ADDENDUM NO. 4

Date: February 1, 2021

Bid Name Clarence R. Kelly Community Center and Park

Bid No.: WSPP-210016-DM

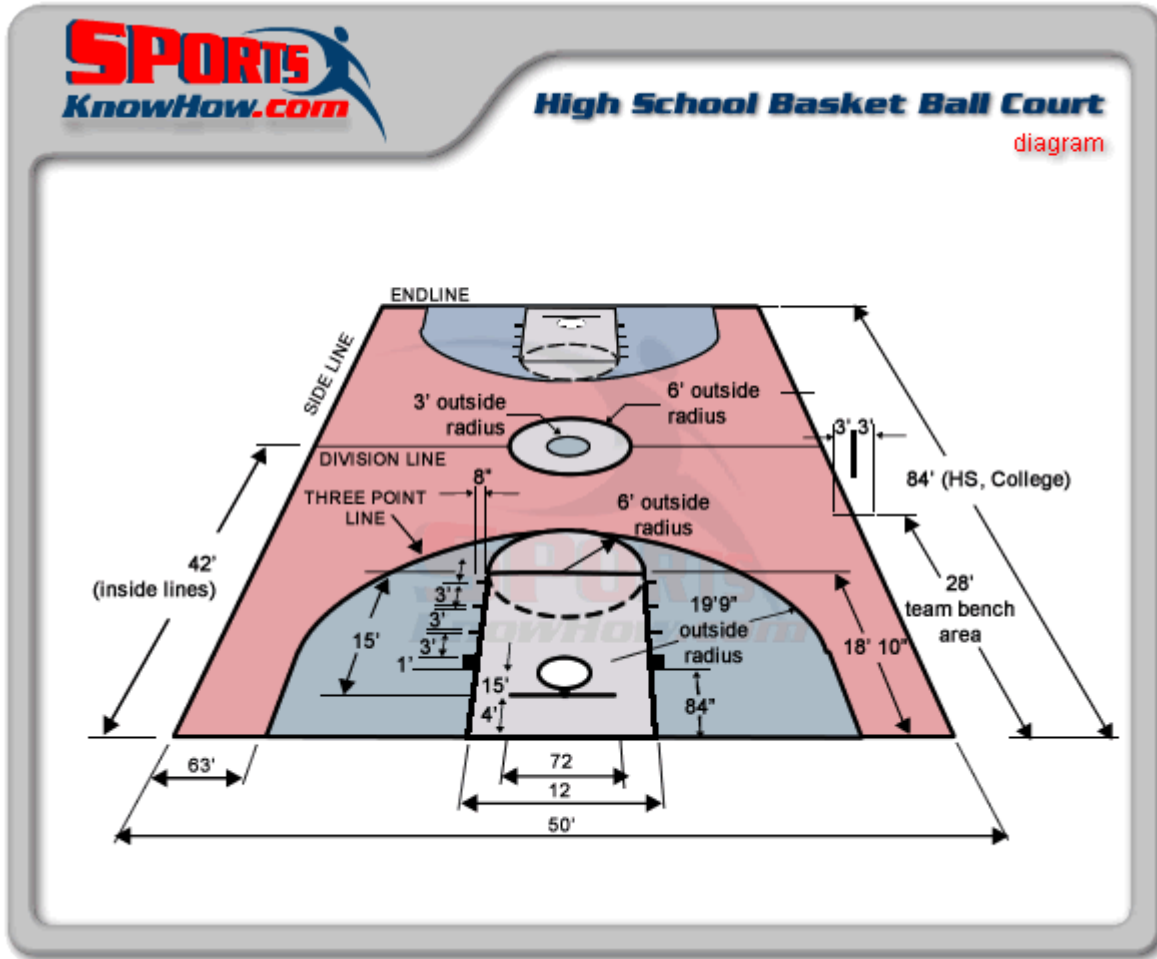
10. Question: Provide outside dimensions (size) for the concrete basketball court, including measurements for the striping layout.

Answer: 88’-4” x 58’-4” striping to follow standard striping shown below:

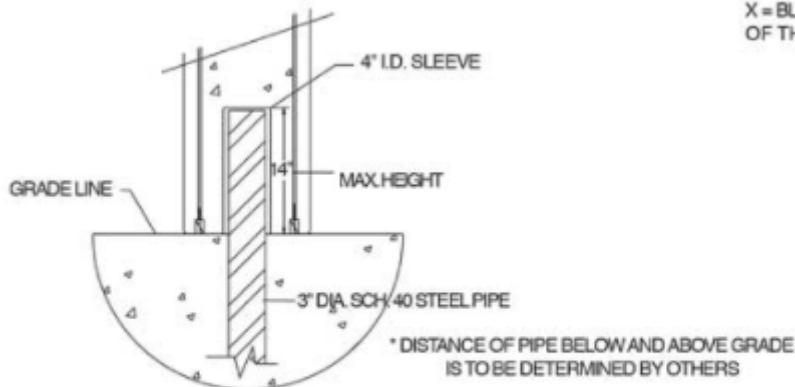
11. Question: Provide details and quantity for the 42" painted concrete bollards noted as Item A180 on Sheet A-001.

Answer: Quantity as per plan.

NOTE: THIS TYPE ANCHORING IS ALSO USED AS A BARRICADE BOLLARD HELD IN PLACE BY STEEL PIPE
 STEEL PIPE MUST BE ANCHORED IN CONCRETE FOOTING
 TYP. 12' DIA. CONCRETE BOLLARD SAME ANCHORING SYSTEM USED ON 14' AND 18' DIA. OR SQ. BOLLARDS

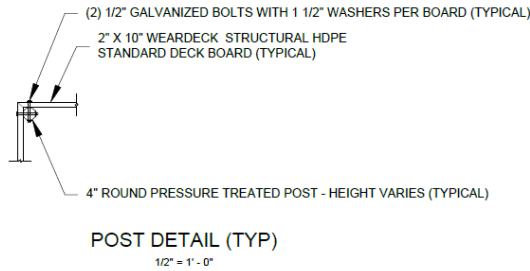
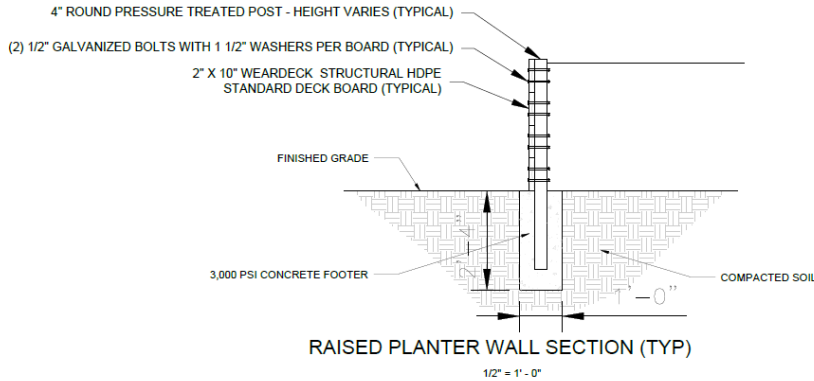
22. Question: Provide details, including finishes and options for the garden shed noted on Sheet A-002.
Answer: Lap siding, left justified 36" standard door, no windows, no interior finish package. Door, eave and siding color to be selected from base color options.

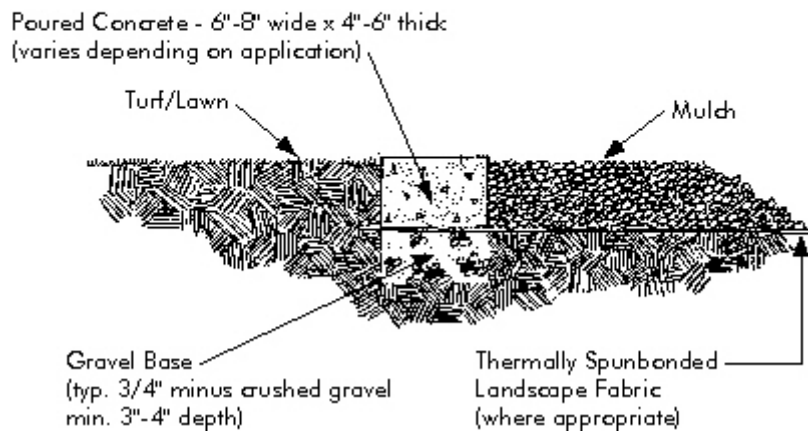
27. Question: Provide a specification and design for the 6 - 4' X 8' raised garden beds as noted on Sheet A-002.

The bottom of the planter will be 2"x 10" WearDeck structural HDPE standard deck boards with 1/4" gaps between the boards for drainage. They shall rest on a bottom rail that is attached to the lowest edge of the sides. The bottom shall then be covered with weed blocking fabric that wraps 6" up each side and 3" of pea gravel for drainage. The remainder is filled with potting soil to within 2" of the top of the planter bed. There should be 12" of potting soil in each planter.

GREASE TRAP

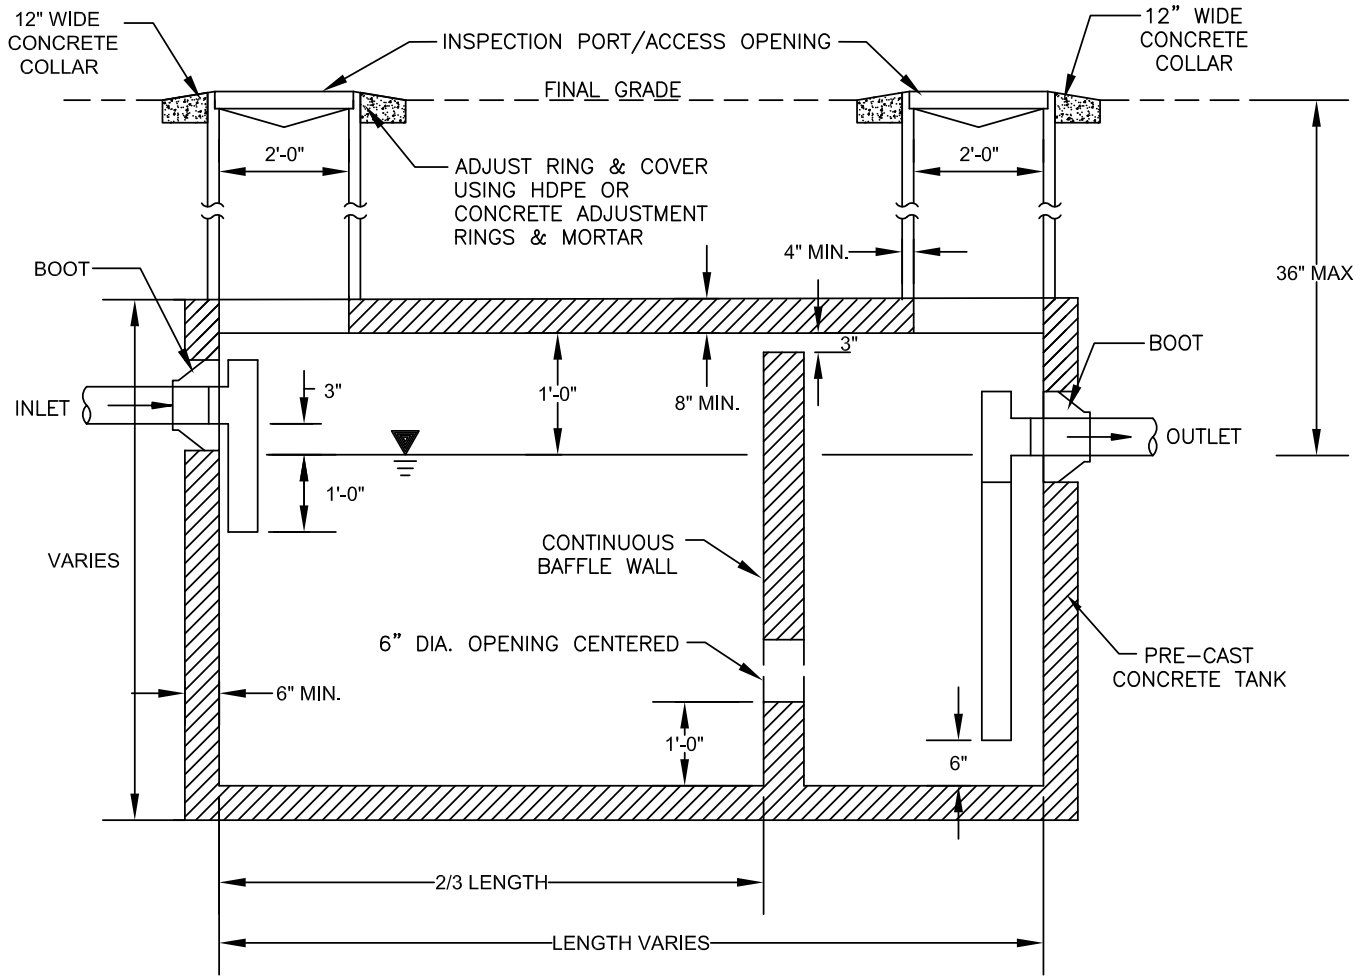
45. Question: Provide a copy of all permits and approvals that alter, modify or change any details or work as shown on the plans.
Answer: All permit comments have been included into the plans and specifications with the possible exception of the Grease Trap Interceptor permit which is attached to this Addendum.

TYPE of TRAP/INTERCEPTOR: INGROUND SIZE: 1,050 gal
 PUMPOUT/CLEAN-OUT FREQUENCY: 60 days

OTHER REQUIREMENTS:
Requirements of this permit including pumping frequency and grease trap/interceptor size are subject to change with change in operations or collection system problems.
